Subject: CI-SRP-7.A-SRSB-03, Markup of DCD Revision 18, Chapter 15-Section 15.4.2

Enclosure 1 provides a markup of Section 15.4.2 of the DCD which has been modified to satisfy the requirements identified in CI-SRP-7.A-SRSB-03.

CI-SRP-7.A-SRSB-03, Markup of DCD Revision 18, Chapter 15

15.4.2 Uncontrolled Rod Cluster Control Assembly Bank Withdrawal at Power

Figure 15.4.2-1

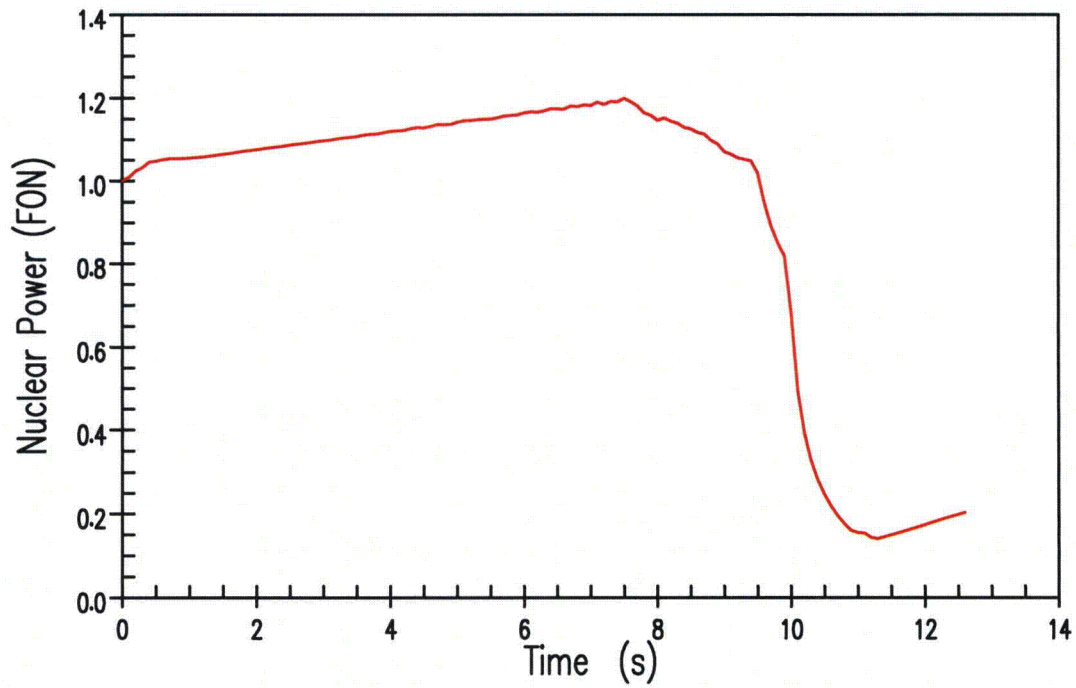
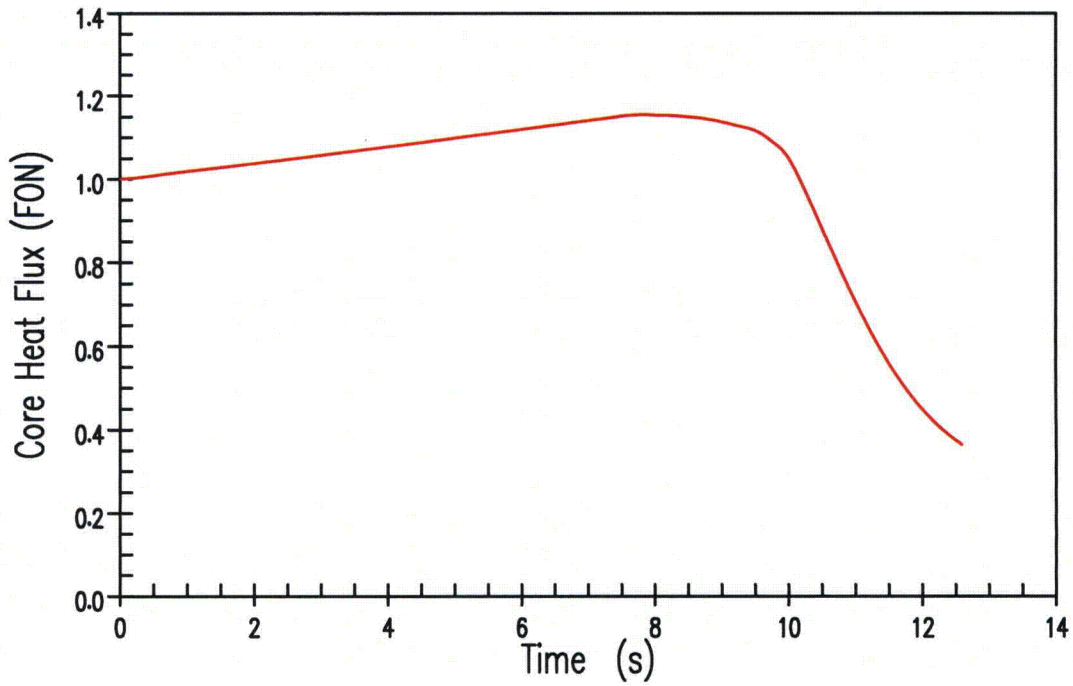
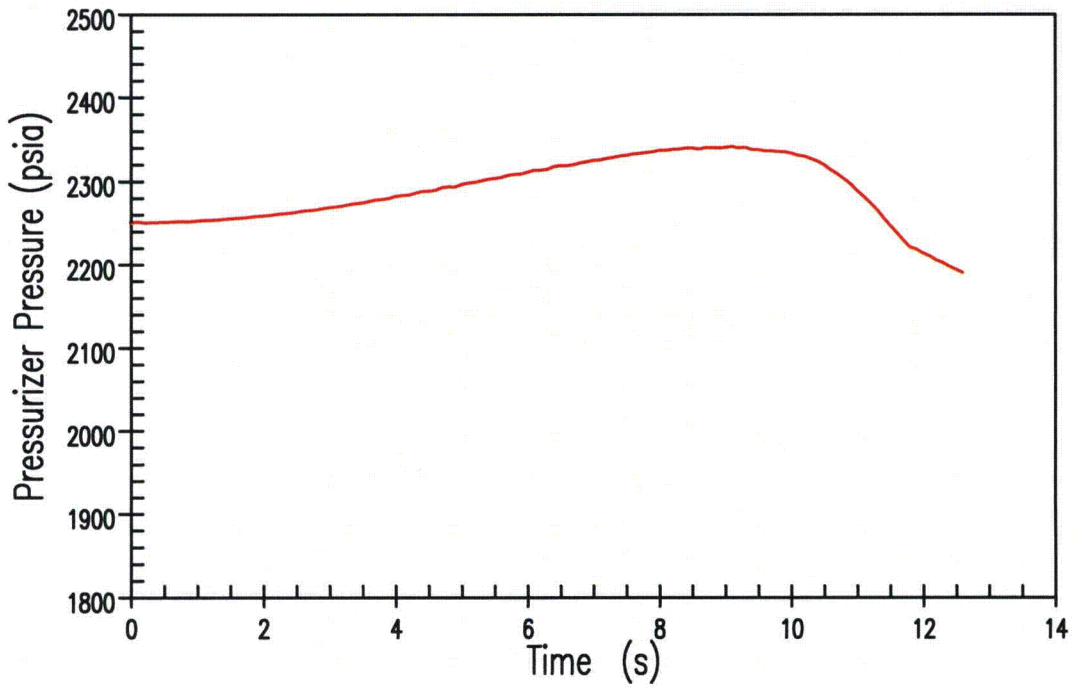
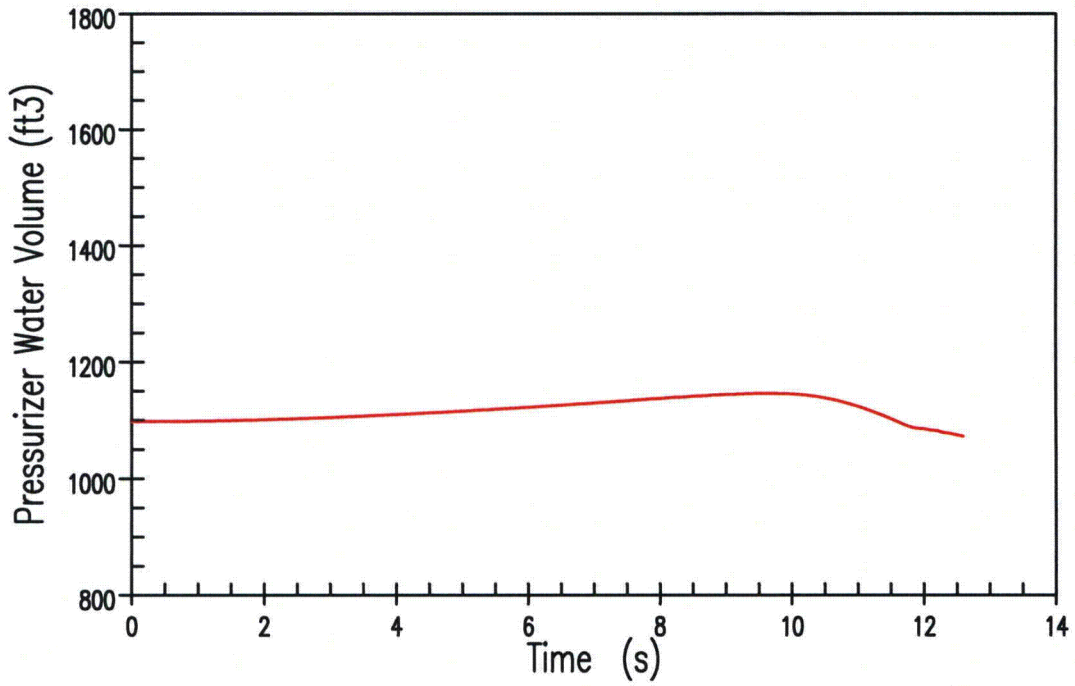
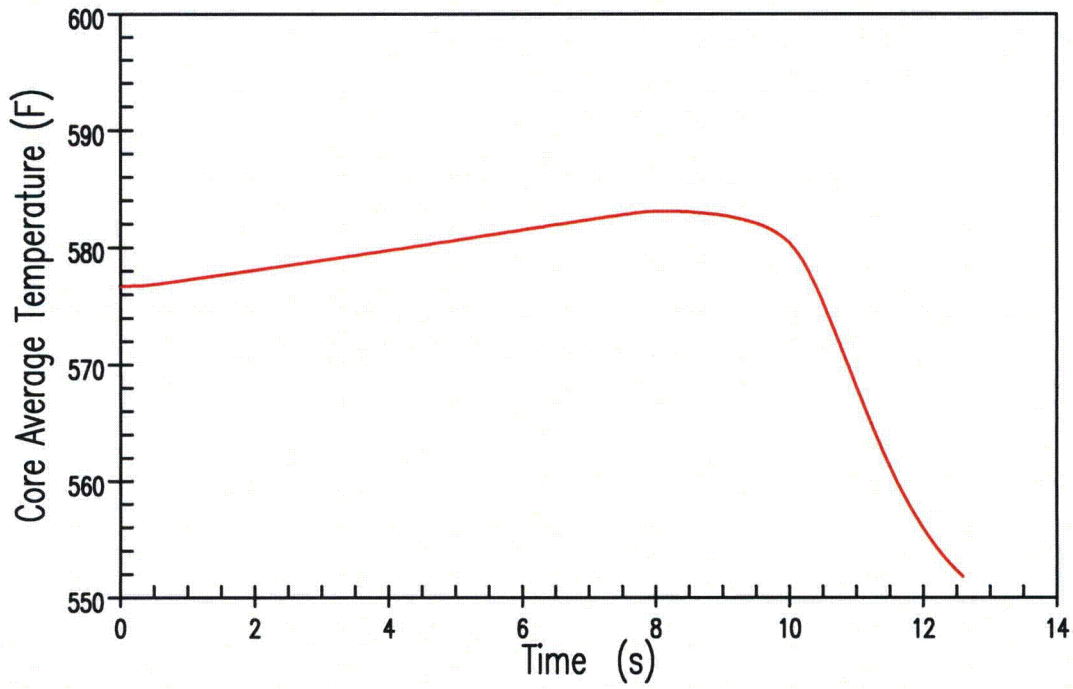
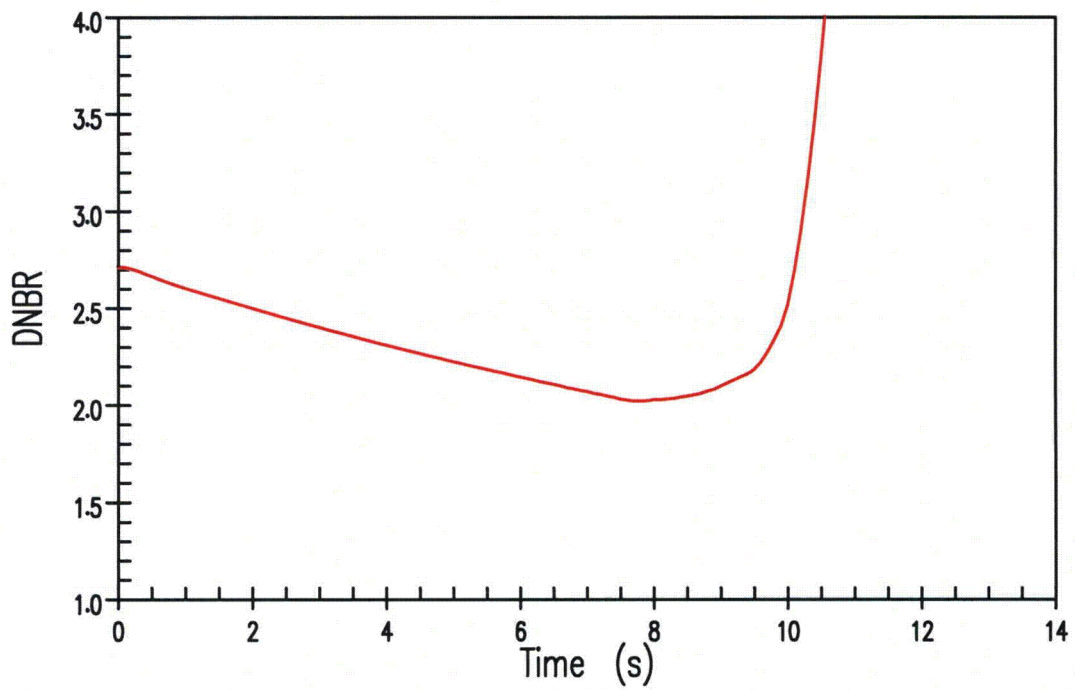
Figures 15.4.2-1 through 15.4.2-6 show the transient response for a representative rapid RCCA withdrawal incident starting from full power with offsite power lost as a consequence of turbine trip. Reactor trip on high neutron flux occurs shortly after the start of the accident. Because this is rapid with respect to the thermal time constants of the plant, small changes in temperature and pressure result, and the DNB design basis described in Section 4.4 is met.

Figure 15.4.2-7

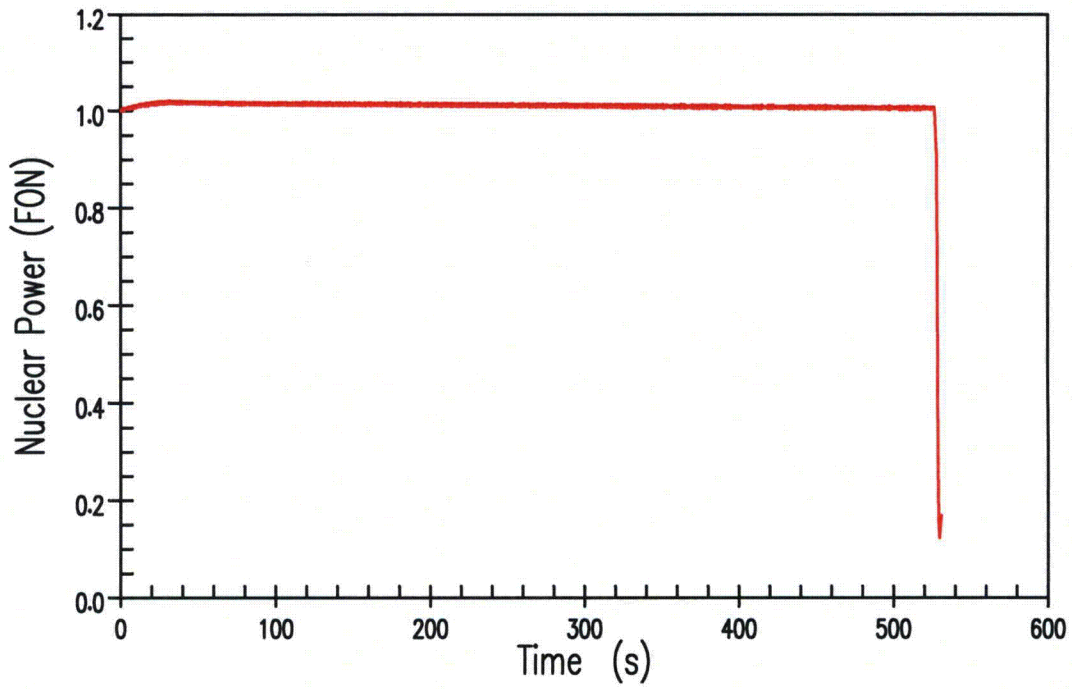
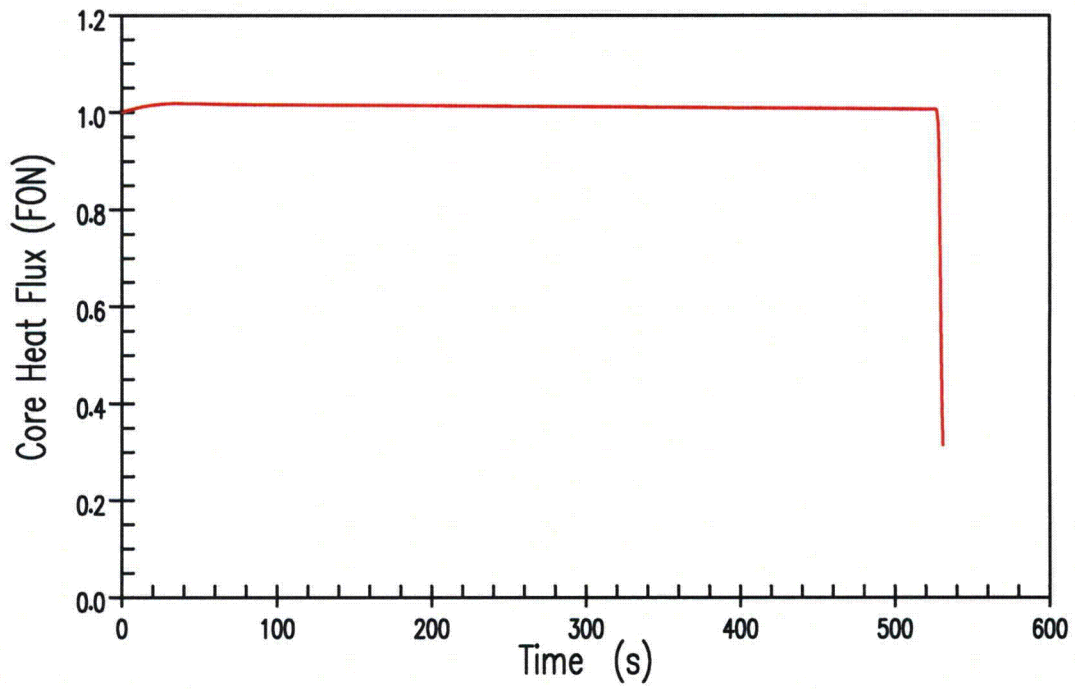
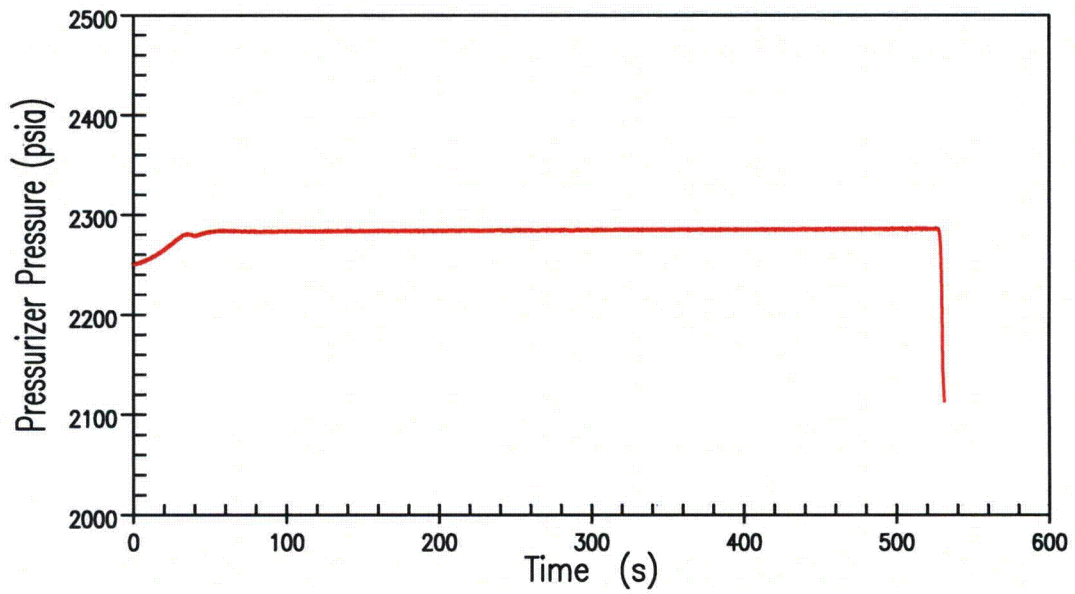
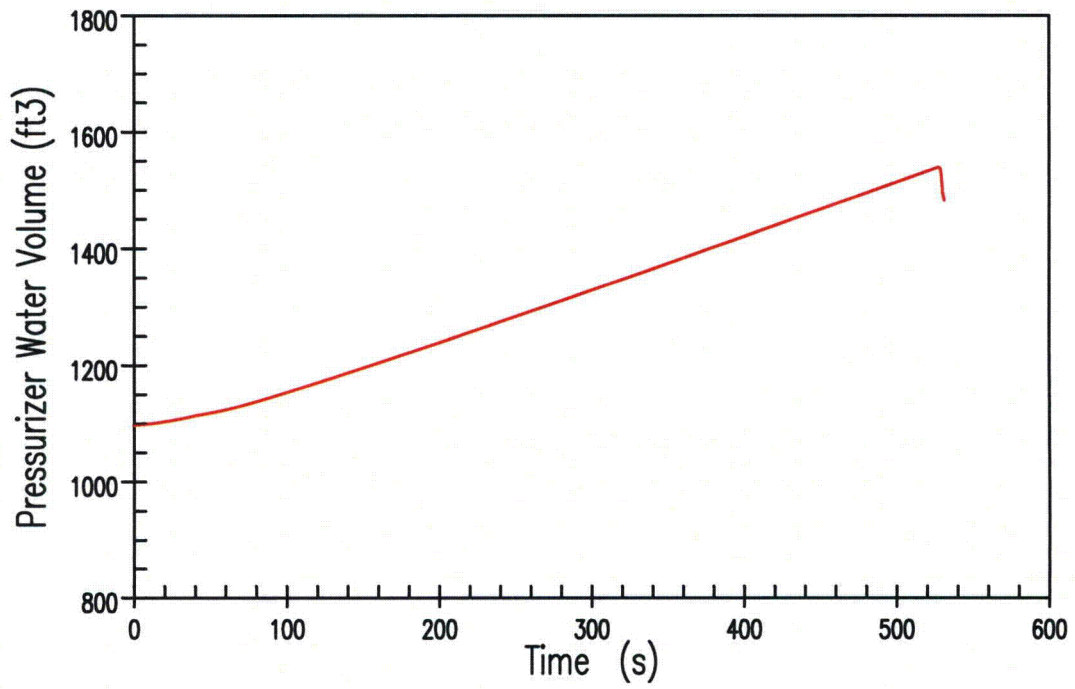
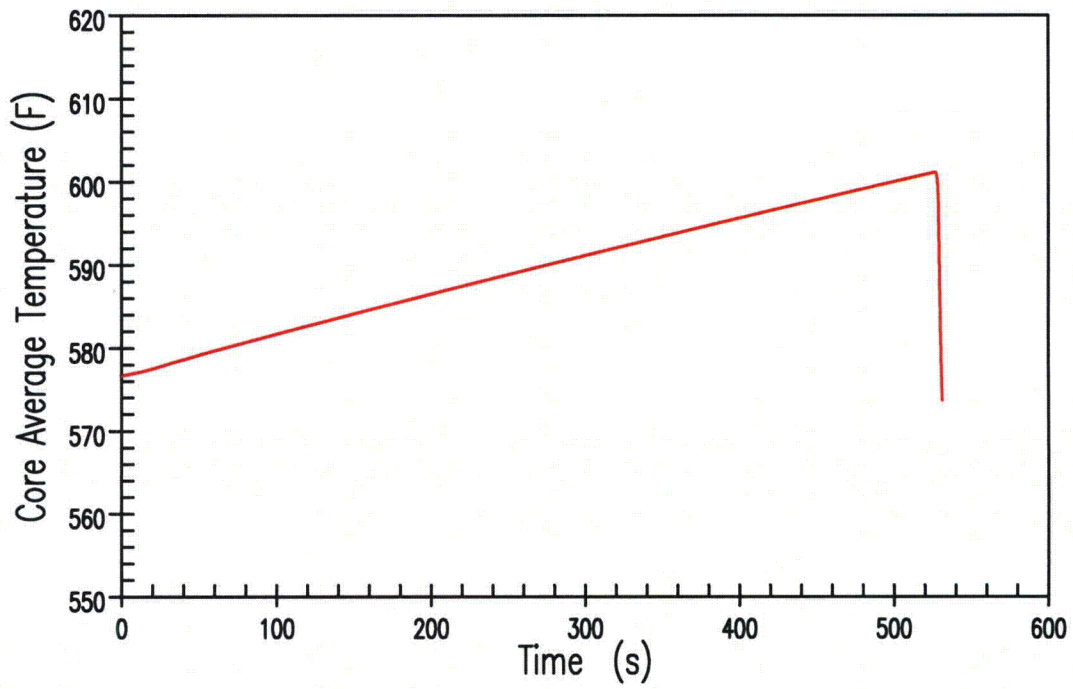
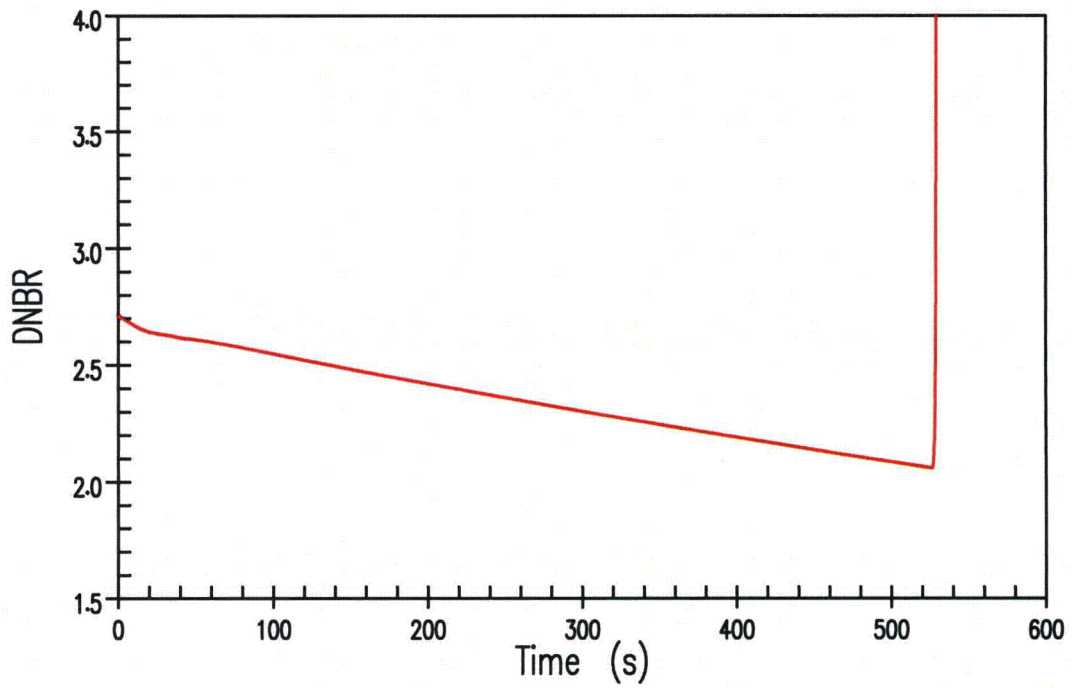
The transient response for a representative slow RCCA withdrawal from full power, with offsite power lost as a consequence of turbine trip, is shown in Figures 15.4.2-7 through 15.4.2-12. Reactor trip on overtemperature ΔT occurs after a longer period. The rise in temperature and pressure is consequently larger than for rapid RCCA withdrawal. The DNB design basis described in Section 4.4 is met.

Figure 15.4.2-13

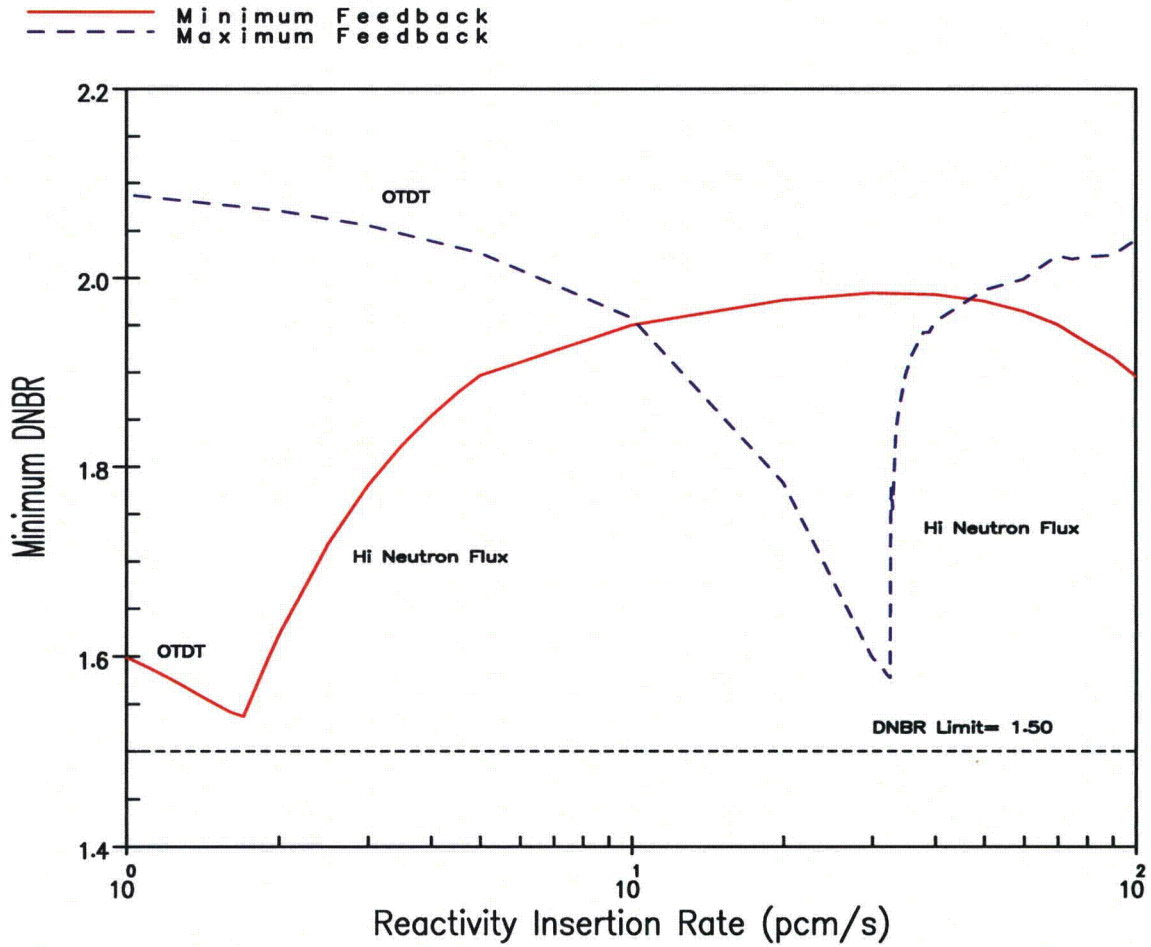
Figure 15.4.2-13 shows the minimum DNBR as a function of reactivity insertion rate from initial full-power operation for minimum and maximum reactivity feedback. Minimum DNBR, occurs immediately after rod motion. Two reactor trip functions provide protection over the whole range of reactivity insertion rates. These are the high neutron flux and overtemperature ΔT functions. The DNB design basis described in Section 4.4 is met.
